Design Review Committee Meeting

Ms. Ardina Pierre has submitted an application seeking approval to demolish the existing home and reconstruct a new 2,622-square foot single-family dwelling with a detached garage at 817 Custer Street. The property is zoned V, Village and located within the Arts District Overlay.

**DEPARTMENT OF PLANNING AND ZONING
PLANNER'S REPORT**

DATE: September 3, 2020
TO: Tonya Hutson
FROM: Lynn Patterson
RE: **Design Review – 817 Custer St Revised**

NORTHEAST (RIGHT) ELEVATION
SCALE : 1/4" = 1'-0"

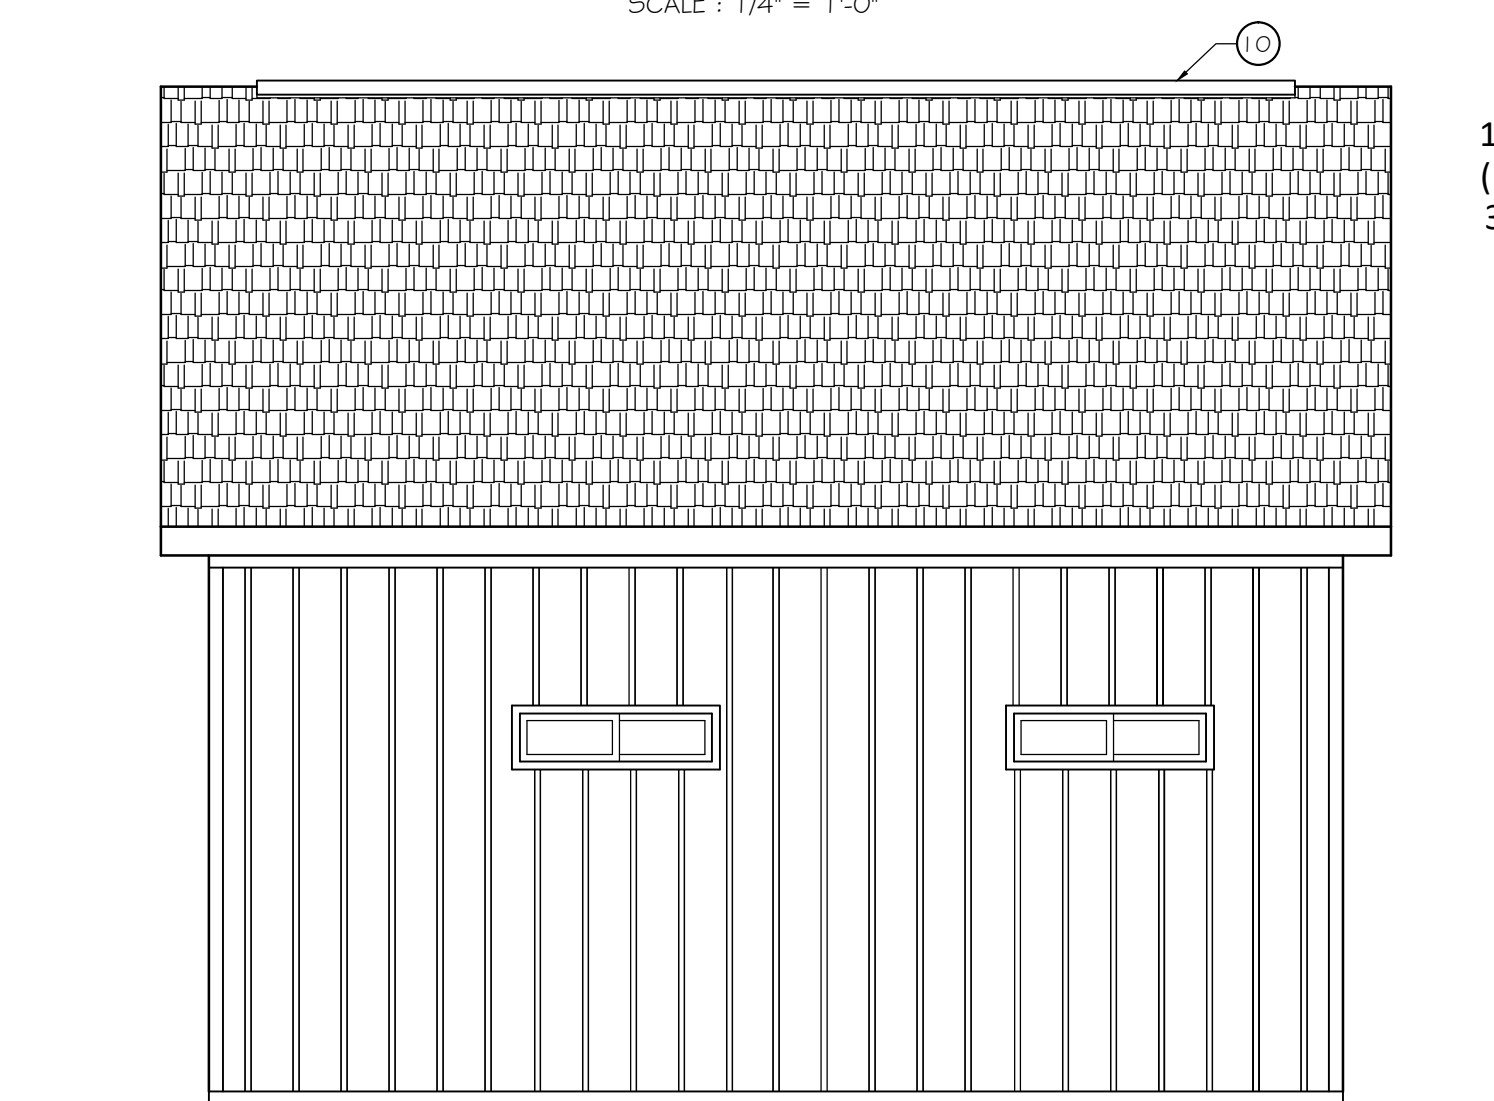
Ensure that the garage is not within 10' of neighboring shed.

- Ensure that each column is spaced a maximum of 8 feet from the center **Provided**
- Buildings numbers must be provided **Provided**
- Provide window dimensions to ensure that the window and door standards are being met, including recess. **Provided**
- Provide trim dimensions to ensure standards are met. Center mullions should be 2" wider than trim. **Provided**
- Provide sill information **Provided**
- Provide dimensions for sills above finished floor elevation. **Provided**
- Ensure that the garage is not within 10' of neighboring shed. **Provided**
